Appl. No.: 10/821,410
Amdt. Dated: 12/14/2005
Off. Act. Dated: 09/14/2005

Amendments to the Drawings:

REMARKS/ARGUMENTS

FIG. 5

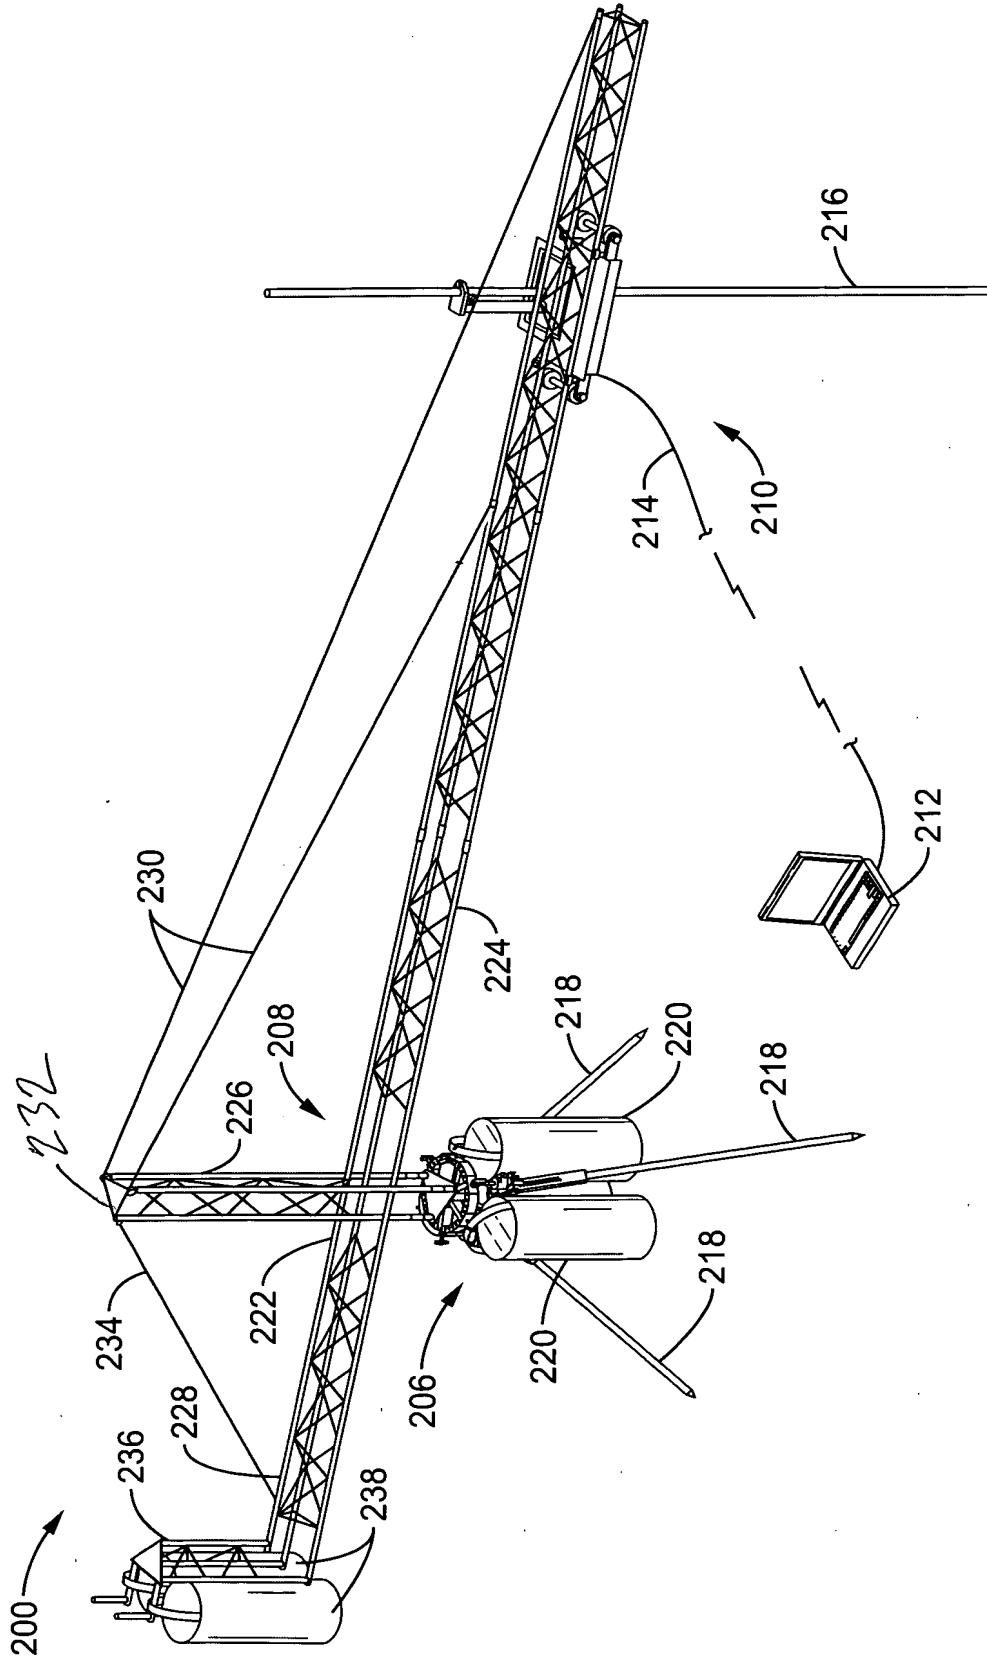
Sheet 5/14, which includes FIG. 5, replaces the original sheet including FIG. 5. In FIG. 5, element 232 was added for the mast top plate (see e.g., paragraph [0082] of the specification).

FIG. 12

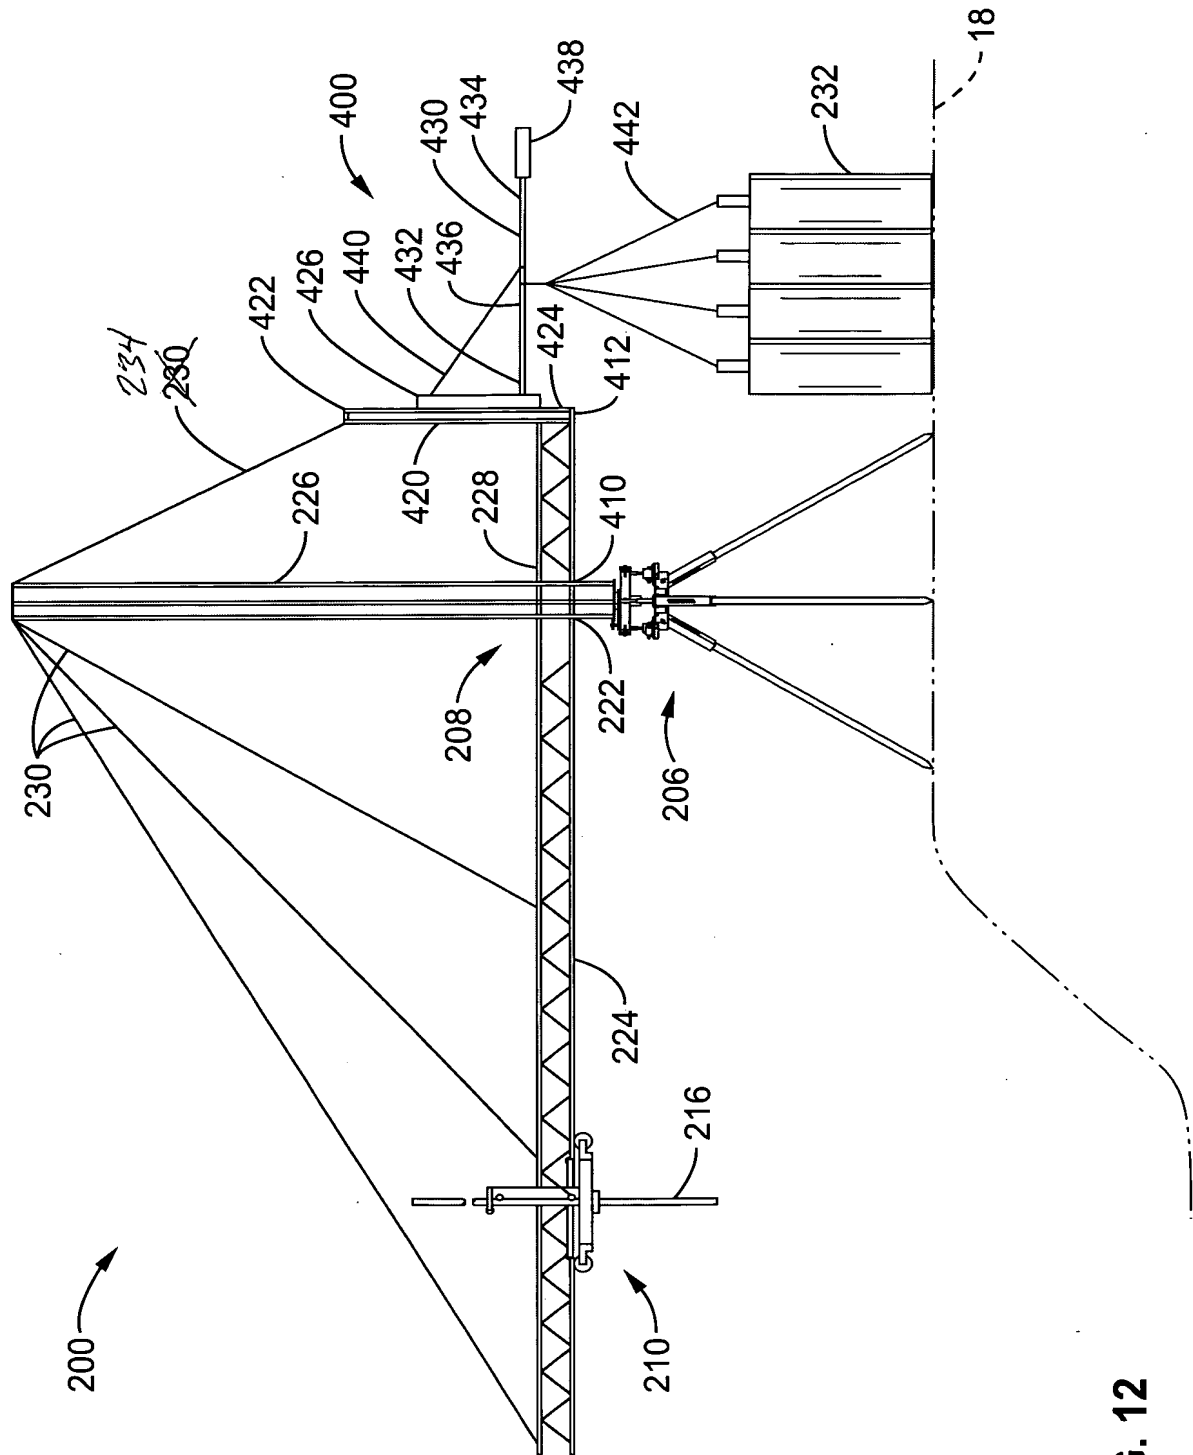
Sheet 12/14, which includes FIG. 12, replaces the original sheet including FIG. 12. In FIG. 12, the support wire leading to element 422 was corrected from 230 to 234 (see e.g., paragraph [0082] of the specification).
